# **BURLINGTON PLACE SUBDIVISION ADDITIONS**

APPLICATION NUMBER 5 DATE April 20, 2006  
APPLICANT Burlington Place Subdivision Additions  
REQUEST Subdivision

# DETAIL SITE PLAN

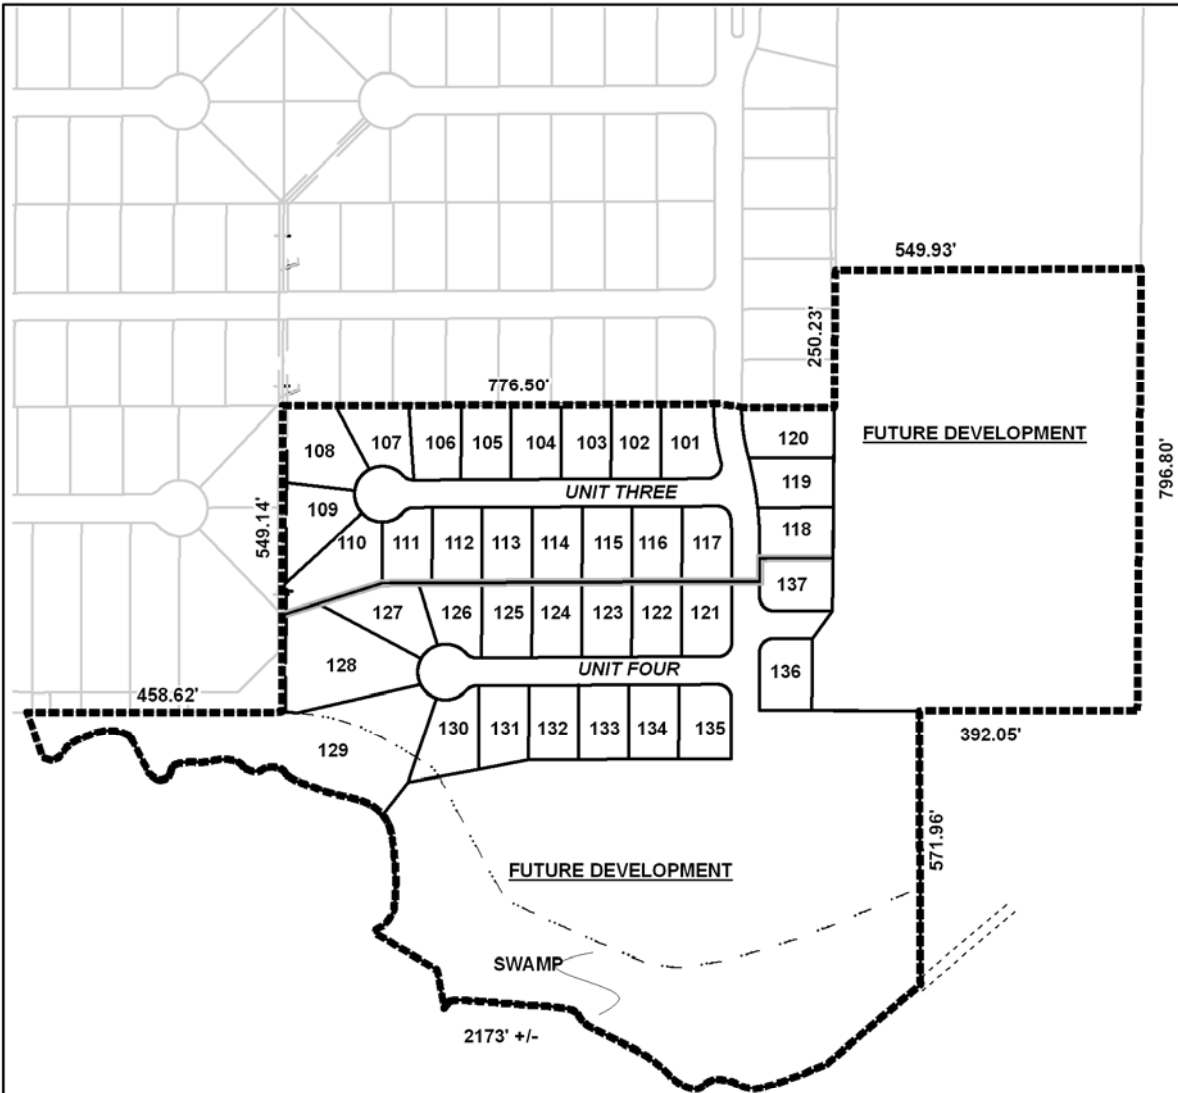
The purpose of this application is to subdivide portions of three parcels into 37 lots and areas reserved for “future development.” It should be noted that the application does not appear to contain the full extent of parcel R023402030000079., specifically the portion of the parcel that fronts onto Cottage Hill Road.

The site fronts onto Burlington Drive East, a minor street with adequate right-of-way. The portion of the parcel not included in the application fronts onto Cottage Hill Road, a proposed major street with a right-of-way of approximately 80 feet. As a major street, the right-of-way for Cottage Hill Road should be 100 feet, thus the dedication of land to provide 50 feet of right-of-way as measured from the centerline should be required.

Units Three and Four, as proposed, generally appear to meet the minimum lot and layout requirements of the Subdivision Regulations, with the exception of proposed Lot 129. This lot occurs at the end of a cul-de-sac, and the wedge shape normally associated with such a lot is distended by approximately 460 feet to include a potential wetlands area, exceeding the depth to width ratio of Section V.D.3. As much of the potential wetlands area may be unsuitable for building, may be required for a drainage easement, and may not otherwise be subdivided in a suitable manner, a waiver of Section V.D.3. could be considered appropriate.

The 25-foot minimum building setback line, required in Section V.D.9., is not shown for the subdivision, but would be required on the Final Plat, if approved.

The southern portion of the site is bounded by Hamilton Creek, and wetlands associated with the creek may occur on a portion of the site. The presence of wetlands indicate that the area may be environmentally sensitive; therefore, the approval of all applicable federal, state and local agencies would be required prior to the issuance of any permits or land disturbance.

This site is located in Mobile County, thus a note should be placed on the Final Plat stating that any lots which are developed commercially and adjoin residentially developed property must provide a buffer, in compliance with Section V.A.7. of the Subdivision Regulations.

The plat is recommended for Holdover until the May 4<sup>th</sup> meeting for the following reason: 1) to allow the applicant to revise the preliminary plat to include the entirety of parcel R023402030000079., and provide additional labels and postage if necessary due to the inclusion of the entire parcel.
